STAFF RECOMMENDATION 113 Lindsley Park Drive June 20, 2012

Application: New Construction – Rear Addition
District: Lockeland Springs-East End Neighborhood Conservation Zoning Overlay
Council District: 06
Map and Parcel Number: 08309046000
Applicant: Edward Smith, Owner
Project Lead: Sean Alexander, sean.alexander@nashville.gov

FRONT ELEVATION

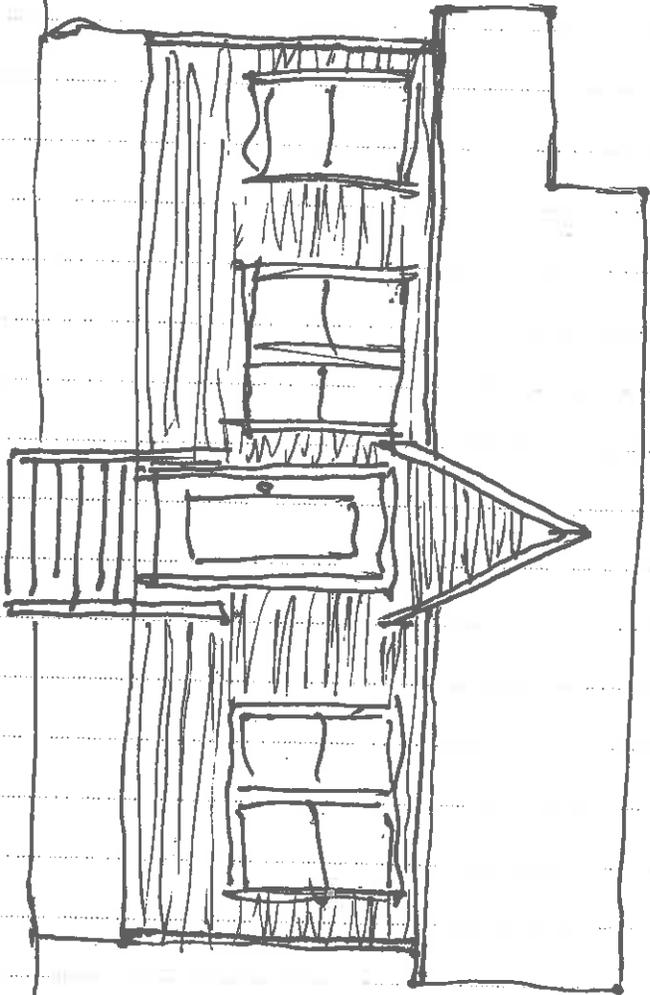
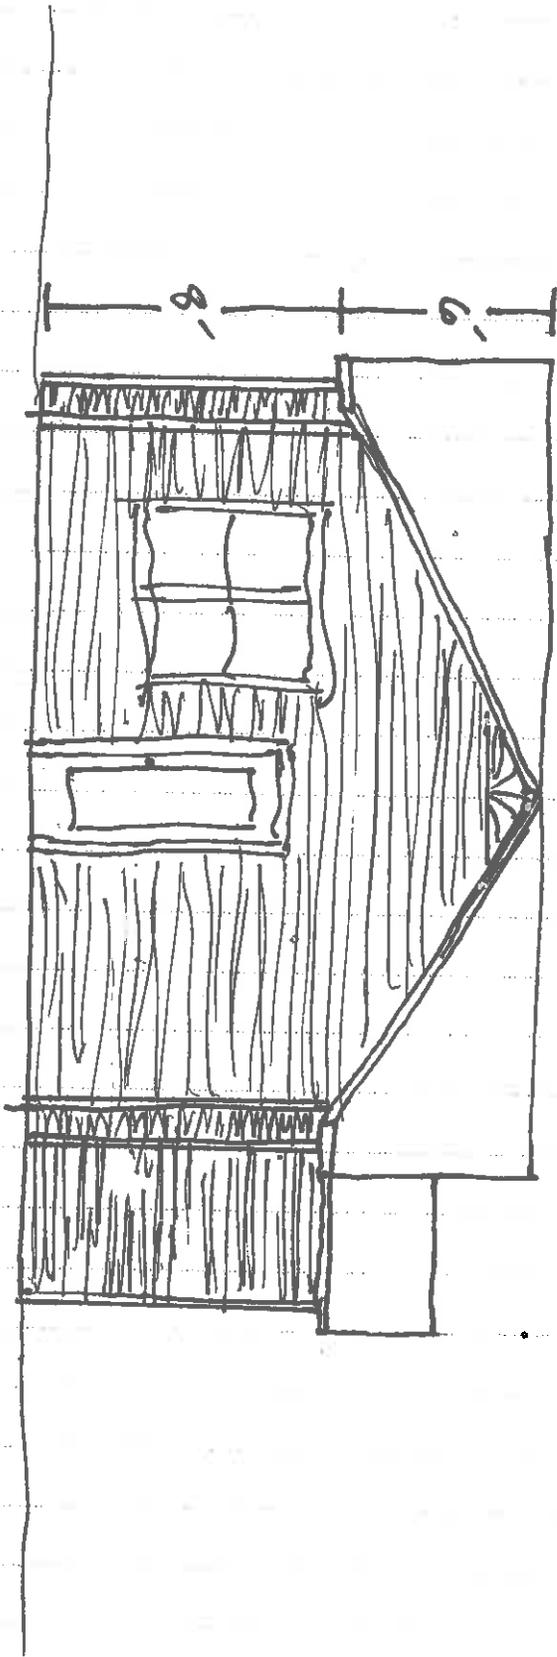
The roof of the addition will be a rear-facing gable with a 7:12 pitch, matching the primary side-gabled roof of the existing house. The ridge will meet the existing ridge and the eaves will match the existing eaves. Staff finds this roof to be compatible and to meet guideline II.B.5.

LEFT SIDE ELEVATION

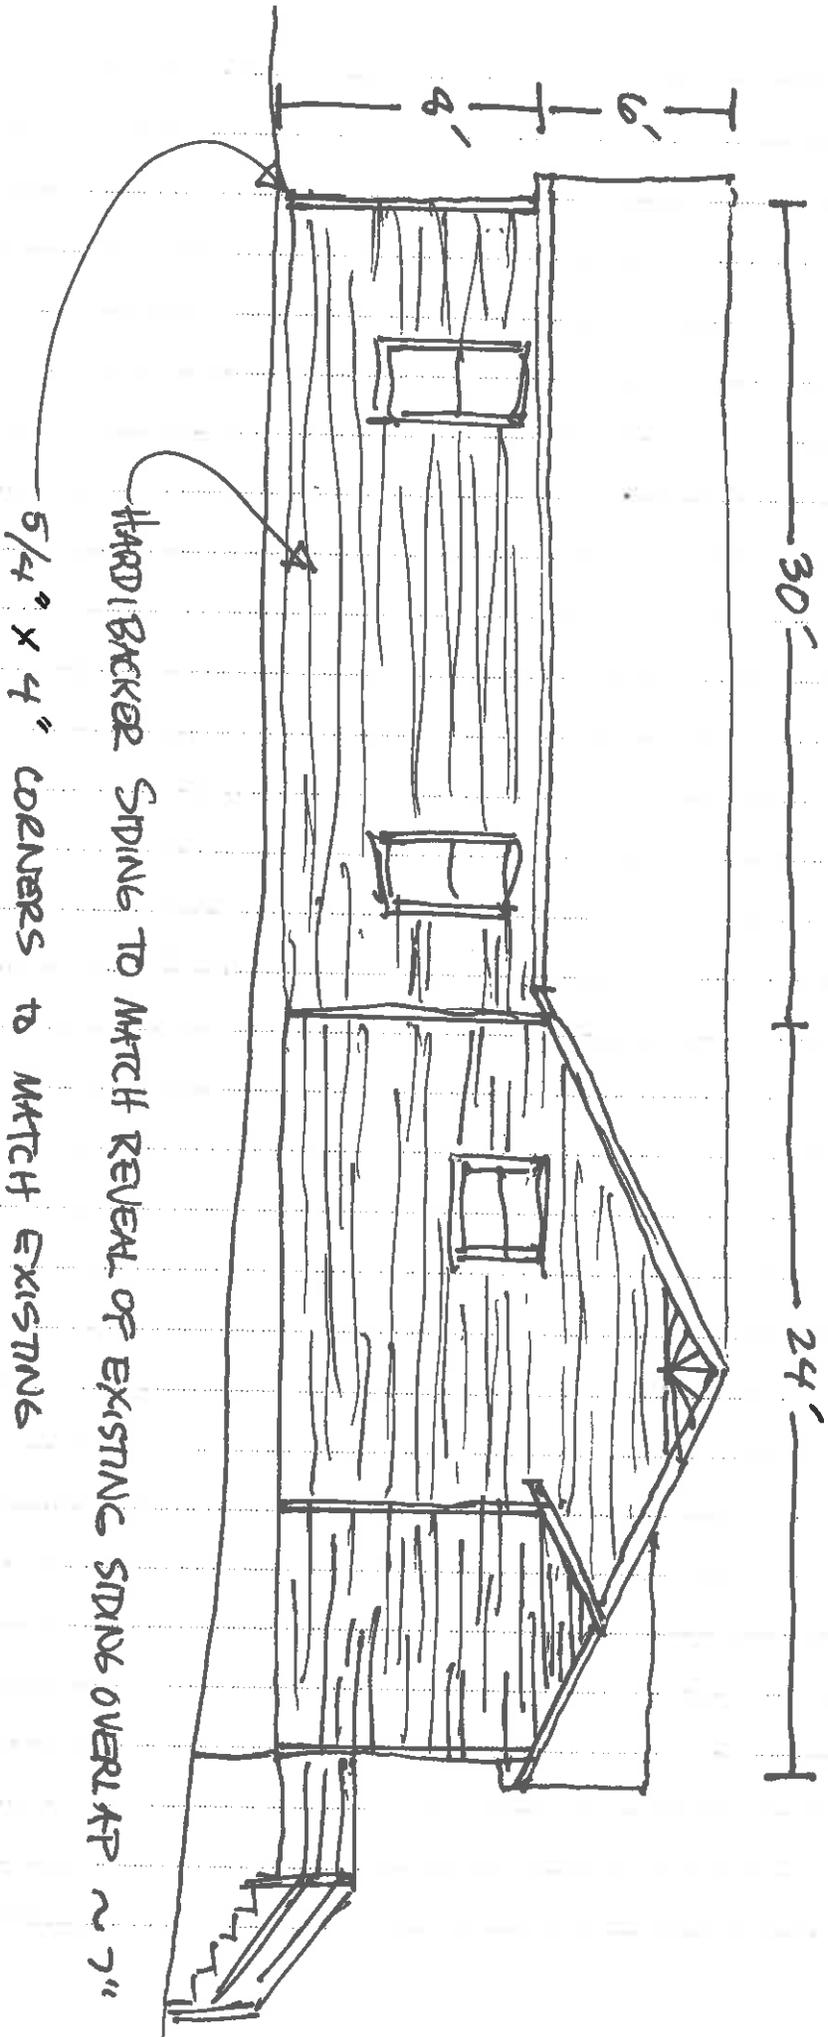
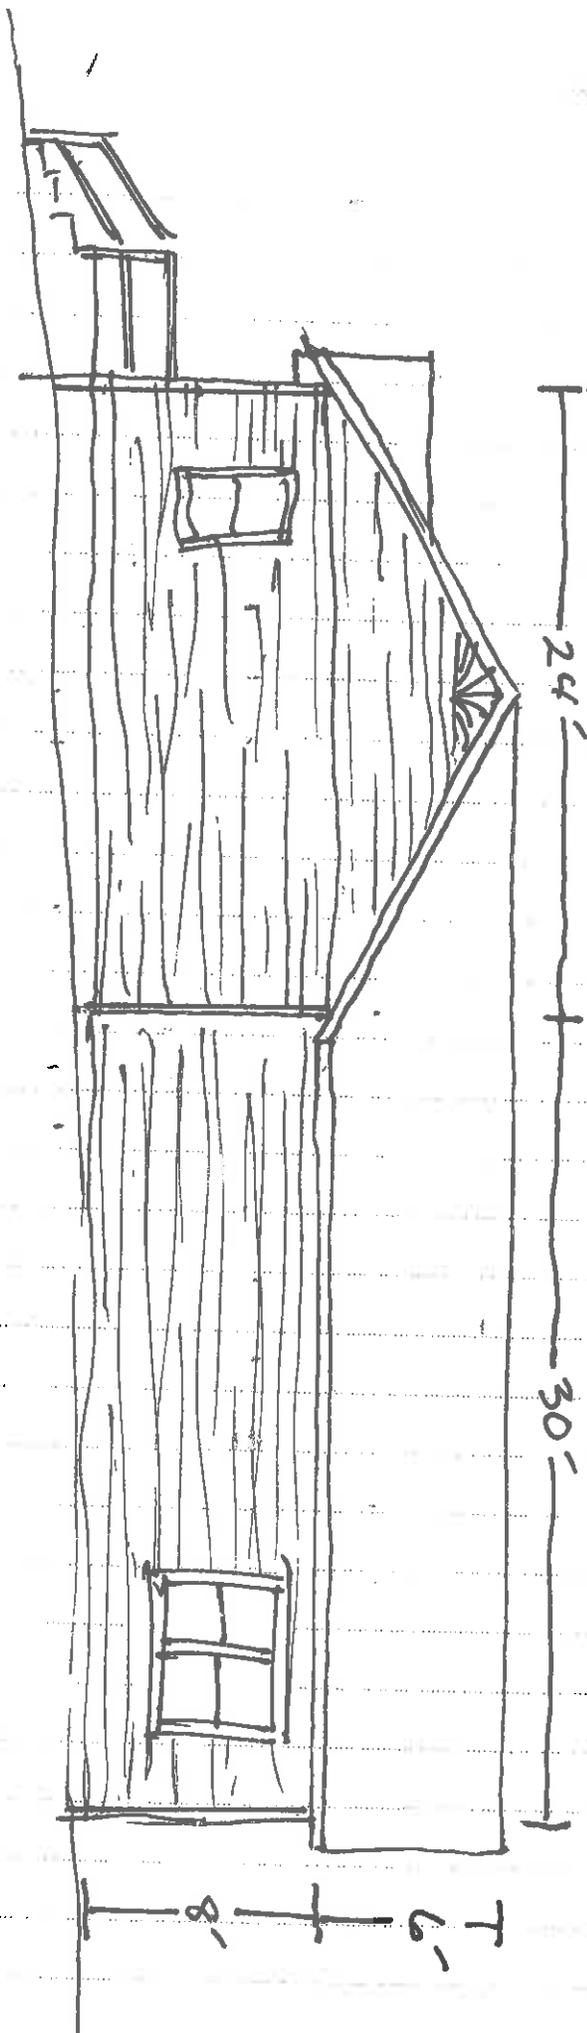
The siding of the addition will be smooth cement-fiberboard with a seven inch (7") exposure, closely resembling the wood siding on the existing structure. The foundation will be parged concrete, the roof will be fiberglass-asphalt single, and the trim will be wood, all matching the existing. The new windows are to be vinyl. To date, the Commission has found that vinyl is not compatible with historic houses; therefore Staff recommends that the new windows be wood. Staff finds these materials to be compatible and to meet guideline II.B.4.

The addition will have two windows spaced evenly on the left side and a pair of windows toward the rear 1/3rd on the right on each side. The new windows be double-hung sash,

roughly twice as tall as they are wide. These windows will be compatible with the existing structure and meet guideline II.B.7.

Staff recommends approval of the proposed rear addition at 113 Lindsley Park Drive with the condition that the windows be wood, finding it to otherwise meet the design guidelines for Additions in the Lockeland Springs-East End Neighborhood Conservation Zoning Overlay.
